MEMORANDUM

Subject: Minor Clarification to the Mattole and Salmon Creek Forest Health and Wildfire Resilience Project PSA/Addendum

The Mattole and Salmon Creek
 Forest Health and Wildfire Resilience Project
 Humboldt County, California

FIGURE 2
Study Area and Proposed
Project Map

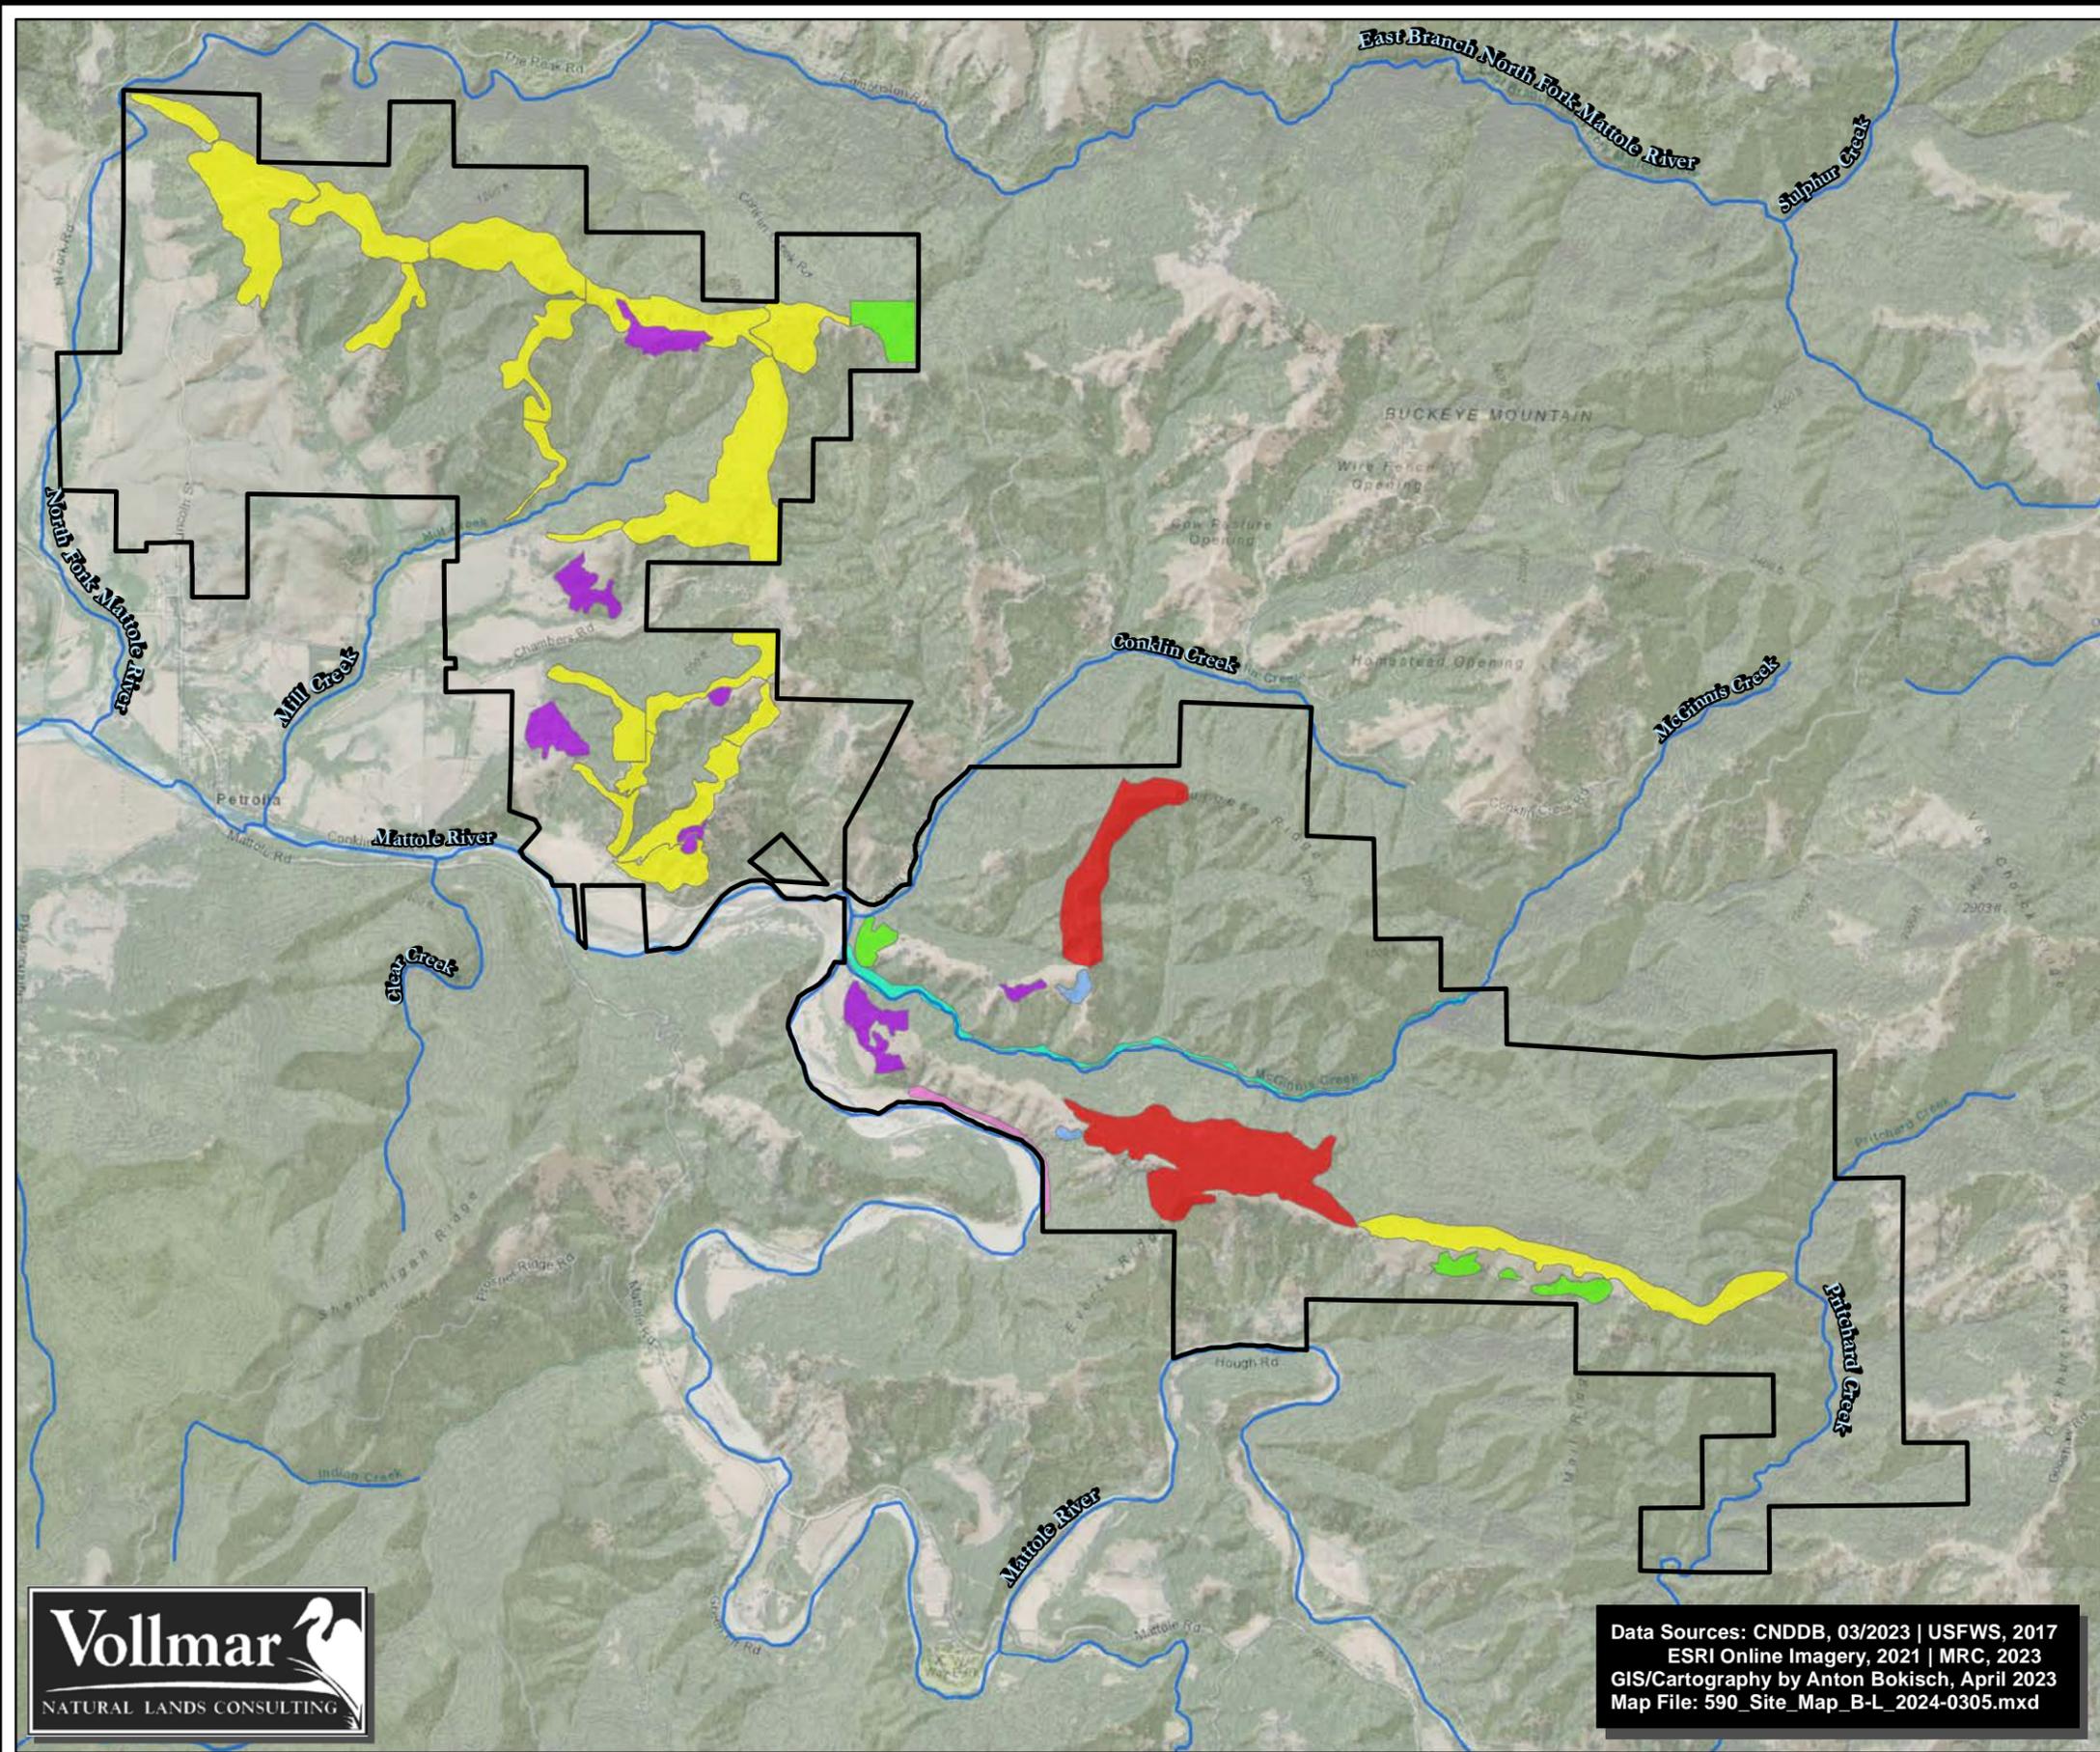
The following revisions to the ‘Figure 2. Study Area and Proposed Project Map’ of the PSA/Addendum text are signified by strikeouts (~~strikeouts~~) where text is removed and by underline (underline) where text is added within the Legend (and corresponding features within the map):

Mechanical and Manual Thinning; Pile Burn (~~68~~ 56 ac.)

Mechanical and Manual Removal; Pile Burn; Native Seeding (~~76~~ 90 ac.)

In-Stream Tree Placement and Riparian Tree Planting (32 ac.)

In addition, ‘Figure 2 – Study Area and Proposed Project Map’ will be replaced with the following map to reflect these changes (see following page):
